Replacing the Cassette Plenum Rail

Document number: 512-00189A

Product	FCO priority
Magnus VLF Autoloader	Next failure

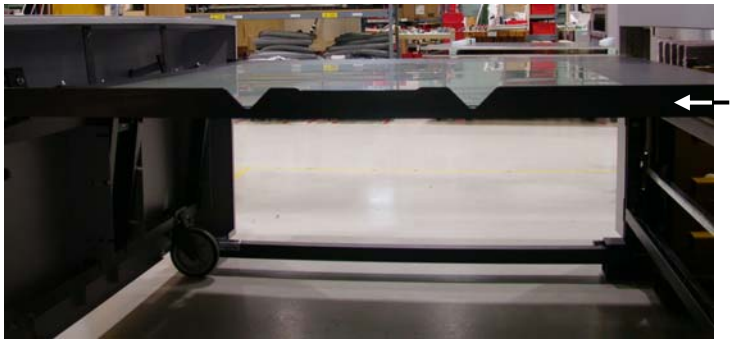
The MCU cassettes are catching on the plenum rollers and are difficult to load into the MCU. The new plenum rails can be identified by the beveled edge on the side closest to the MCU.

Old cassette plenum rail

New cassette plenum rail

Replace the plenum rail on all cassettes.
